City of Bellingham
CITY COUNCIL AGENDA BILL

SUBJECT	FOR AGENDA OF	COUNCIL ASSIGNMENT	BILL NUMBER
Staff Update on the Birchwood-Meridian Corridor Analysis	09-08-08	TRANSPORTATION	018115
	TIME REQUIRED	DEPART. CONTACT	RECEIVED IN COUNCIL OFFICE
ATTACHMENTS Technical Memo Conceptual Sketch	5 minutes	Tom Rosenberg	SEP 02 2008
	CLEARANCES	INITIAL	DATE
	Dick McKinley, PW Director	<i>YAM</i>	29 Aug 2008
CATEGORY			
<input type="checkbox"/> Public Hearing <input type="checkbox"/> Other <input type="checkbox"/> Evening Presentation <input type="checkbox"/> Special Meeting <input checked="" type="checkbox"/> Committee Briefing Ordinance: <input type="checkbox"/> Mayor's Report <input type="checkbox"/> Briefing/Discussion <input type="checkbox"/> Consent Agenda <input type="checkbox"/> Introduction or Expedited	Legal	<i>JH</i>	8-29-08
	Mayor or CAO	<i>TGW</i>	9-2-08
SUMMARY STATEMENT:			
<p>The Birchwood Sidewalk project was originally budgeted in 2004 to construct pedestrian improvements on Birchwood Ave from Meridian Street west approximately 800 feet to the end of the existing sidewalk. As the design proceeded, it was determined that a right-turn lane and traffic signal upgrades were need

Figure 3 – Preferred Concept E

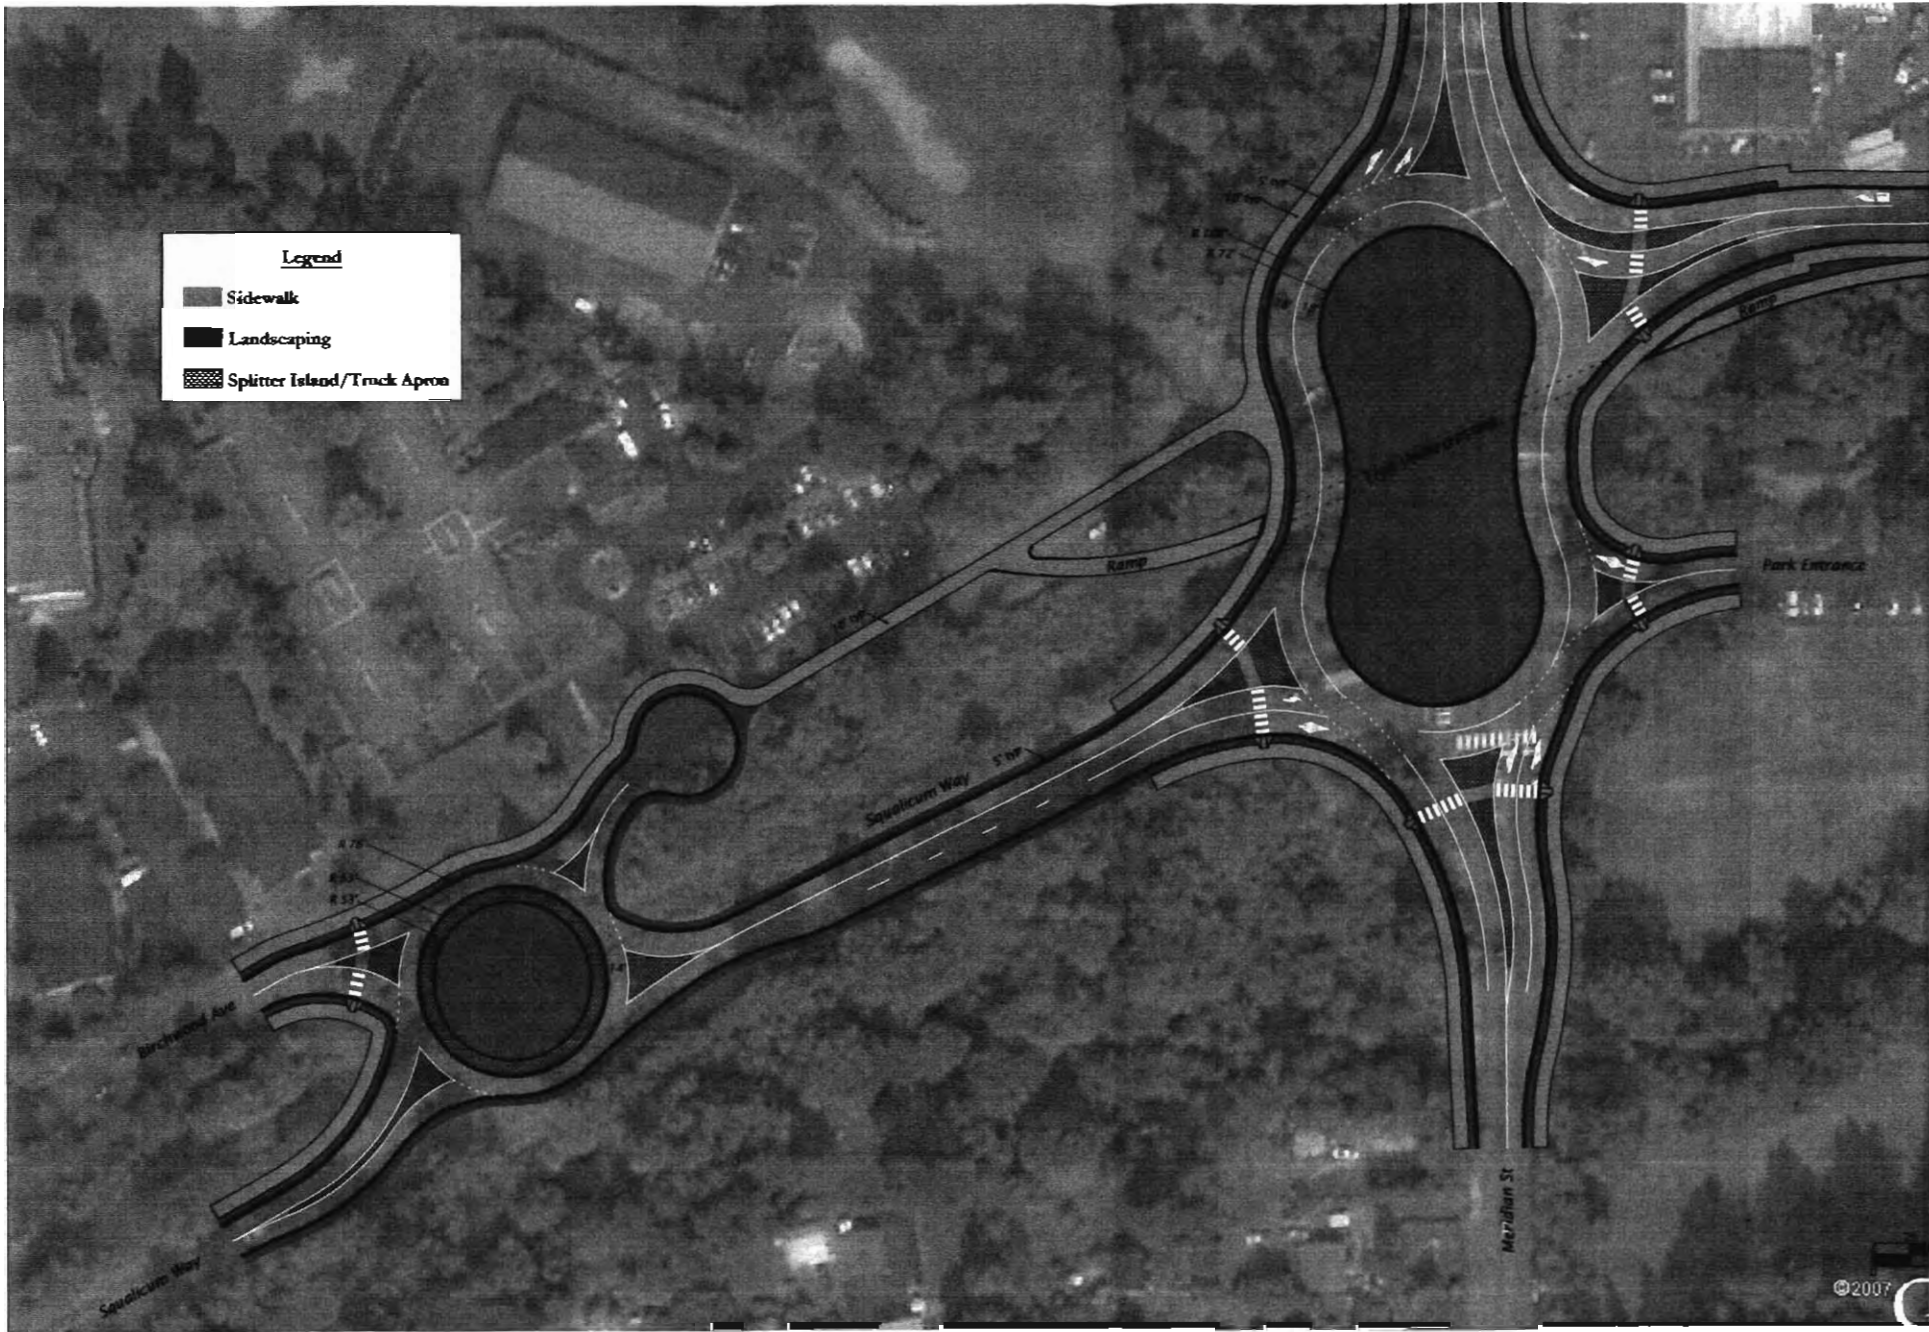
Following City staff's review of Alternative Concept E, the following additional comments/questions were raised:

- Eliminate the westbound to northbound right-turn bypass. This will eliminate the need for a merge onto Meridian north of the roundabout. This would also reduce the potential impact to Cenex and increase the ability to safely cross pedestrians at the north leg of the roundabout.
- Further review the necessity for 18-foot travel lanes within the Meridian roundabout. The concern is that these large widths may cause traffic to flow faster than desirable within the roundabout.
- Need to address where the BGCC maintenance facility driveway gets its access – there is currently nothing shown.
- Increase the width of the shared-use path from 10 feet to 12 feet.

Upon review of these comments, our team agrees that each of these elements should be carefully considered when moving forward into the next stages of design.
